End Wall Installation Change

March 15, 2018

Figure 1: View of the two downstream end walls' connection to the CPA bridge beam clevis.

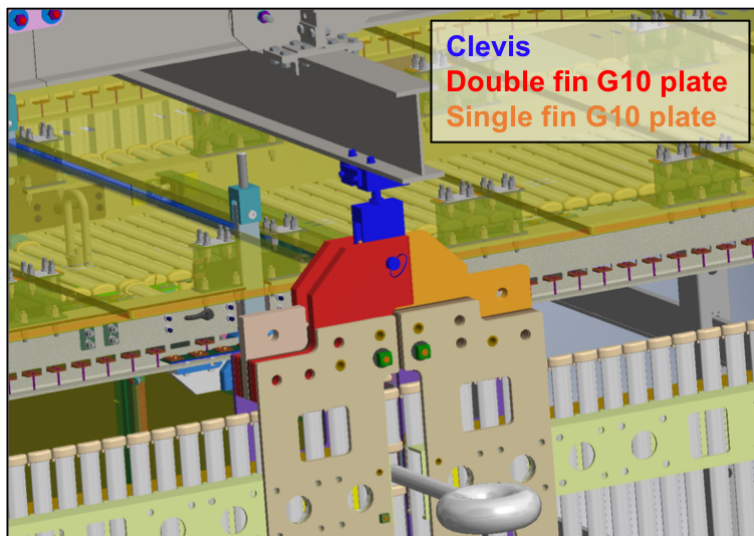
Once in their final positions, each end wall will be supported from the top at both corners - one on an APA bridge beam and one on the CPA bridge beam. The connections on the CPA bridge beam needs to accommodate two end walls. This is achieved by first attaching one of the end wall's connecting plate inside a bridge beam clevis with a hollow sleeve, and next attaching the other end wall's connecting plates around the clevis with a solid pin. The final arrangement is shown in Figure 1.

The problem is that the installation sequence requires the downstream (DS) beam right (BR) end wall with the double fin plate (red in Figure 1) to be installed before the DS BL end wall with the single fin plate (orange in Figure 1). In this case the solid pin will block the access for the downstream beam left end wall to be connected.

The simplest and safest solution we have come up with is to simply wait to make the final connection of the DS BR end wall until after the DS BL end wall load has been transferred to the CPA/APA bridge beams. We propose the following sequence of events:

1. Temporarily transfer the DS BR end wall load to the CPA/APA bridge beams, so that bridge beam B is free to deploy the BR top/bottom field cages.
2. Once this is done the load can be transferred back onto the lift beam connected to bridge beam B, and the connections on the CPA/APA bridge beams removed.
3. Continue to build the BL end walls and push into the cryostat.
4. Close TCO.
5. Install US BL end wall on CPA/APA bridge beams.
6. Remove lift bar from US BL end wall and lower to cryostat floor.
7. Install DS BL end wall on CPA/APA bridge beams.
8. Remove lift bar from DS BL end wall and lower to cryostat floor.
9. Install DS BR end wall on CPA/APA bridge beams.
10. Remove lift bar from DS BR end wall and lower to cryostat floor.

This plan requires an additional lift bar¹, which is available at Ash River and can be sent to CERN immediately (~2 weeks to ship). It also adds one additional scaffolding and winch trolley movement - in order to remove the lift bar for the DS BR end wall.

¹It may be possible to move step #2 after step #6 and reuse the lift bar from the US BL end wall.
